SUBJECT: Contaminant Migration Modeling of Lead and Heavy Water within C-Reactor (105-C) (U) (SRNS-OS-2023-00213, Revision 1, August 2025) and Savannah River Site's Responses to the Regulatory Comments on the Revision 0 Document, SEMS Number: 79

Comments Received May 8, 2025

**SRS Responses to SCDES Comments on the Contaminant Fate and Transport Modeling
for C-Reactor Lead and Heavy Water Sources, SEMS Number: 79, (SRNS-RP-2025-00161)
and Supporting Documents, March 2025
Savannah River Site, Aiken, South Carolina**

Figure CR-1. Process Area lead in photo taken during maintenance activities in March 2007 (Specific Comment #1)

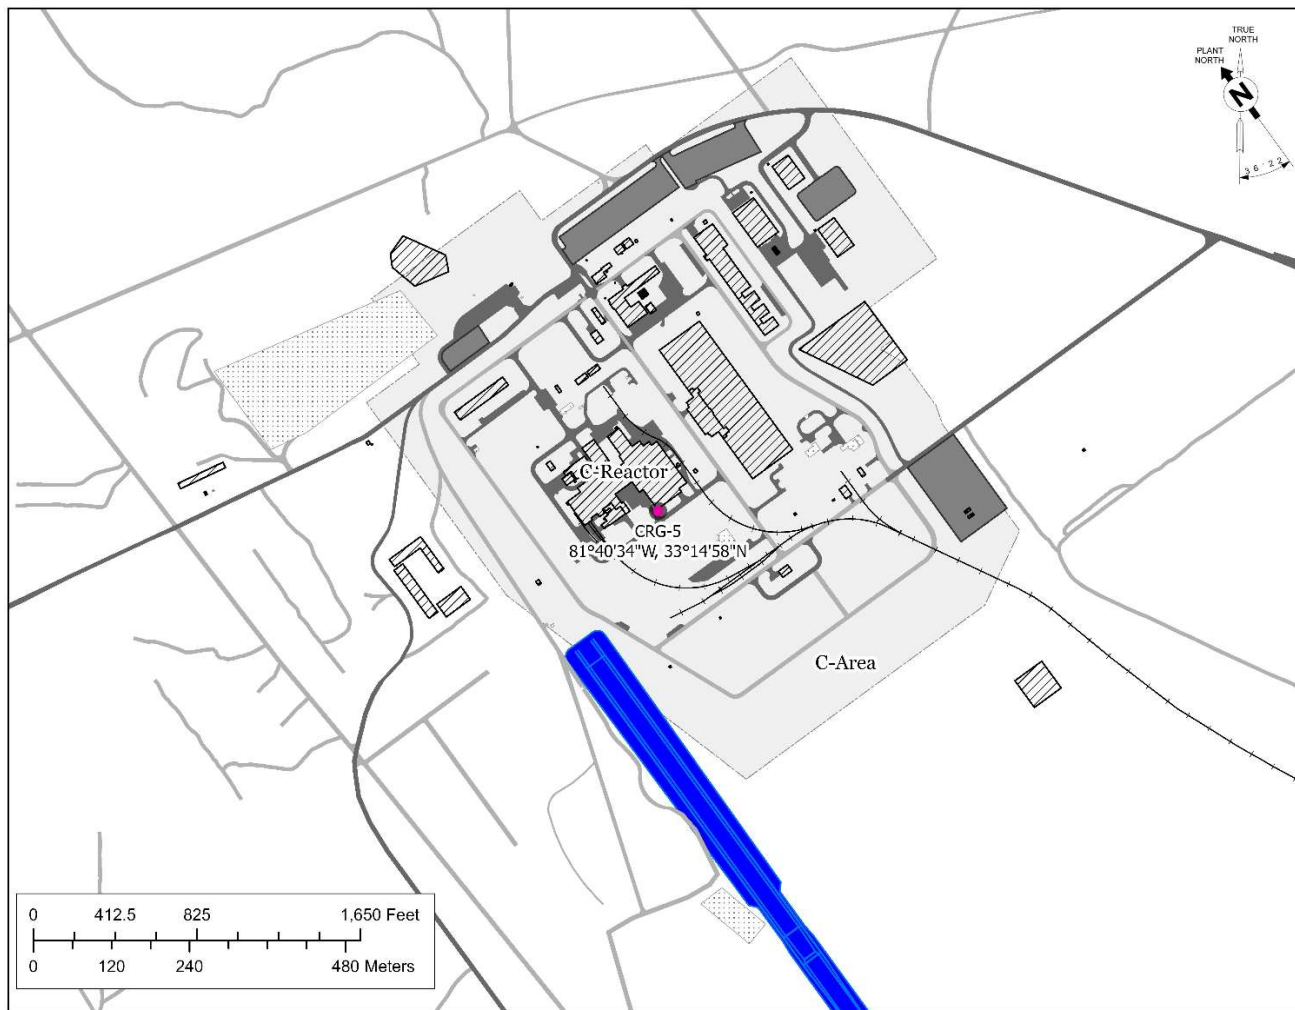
1. Section 2.3.1, 20-ton Process Area Lead Source, page 17. It is stated in the first paragraph that an accurate account of the amount of lead in the process area was not available at the time of this modeling effort; however, the next paragraph states that the thickness for the lead shielding in the process area was estimated from using the mass of lead (20 tons). This implies that the mass of lead was already known, and therefore, contradicts the statement from the previous paragraph. It is unclear whether the thickness of the lead shielding was derived from a known mass of lead, or if the mass of lead was calculated based on an estimated lead thickness. Please clarify how the 20 tons of lead mass was calculated.

SRS agrees that the explanation for the 20 ton lead source in the Process Area needs clarification. The first paragraph stating that an accurate account of the lead was not available, refers specifically to the location and layout of the lead within the Process Area. However, it is also true that the lead inventory (e.g., bricks, sheets, and blankets) was estimated by inspection of pictures taken during vessel maintenance in March 2007 (example in Figure CR-1) and by visual observation from the doorway to the Process Area room by engineers with process knowledge of the lead shielding forms used. The shielding inventory was estimated using these methods and then a mass was calculated based on these estimates. In order to determine a more accurate lead source inventory, it would require entry into the Process Area, requiring proper training and planning, and risking exposure to site workers.

The majority of lead within the Process Area was left surrounding the reactor vessel assembly (Figure CR-1). Therefore, the subcontractor used a conservative estimated lead source mass, the area surrounding the reactor vessel assembly, and the density of lead, to determine a lead thickness and ensure an inherent safety margin. The lead thickness is an input for the GoldSim[®] model structure.

Figure CR-1 will be added to the Chapter 2 figures as Figure 2.2. Other Chapter 2 figures will be renumbered appropriately.
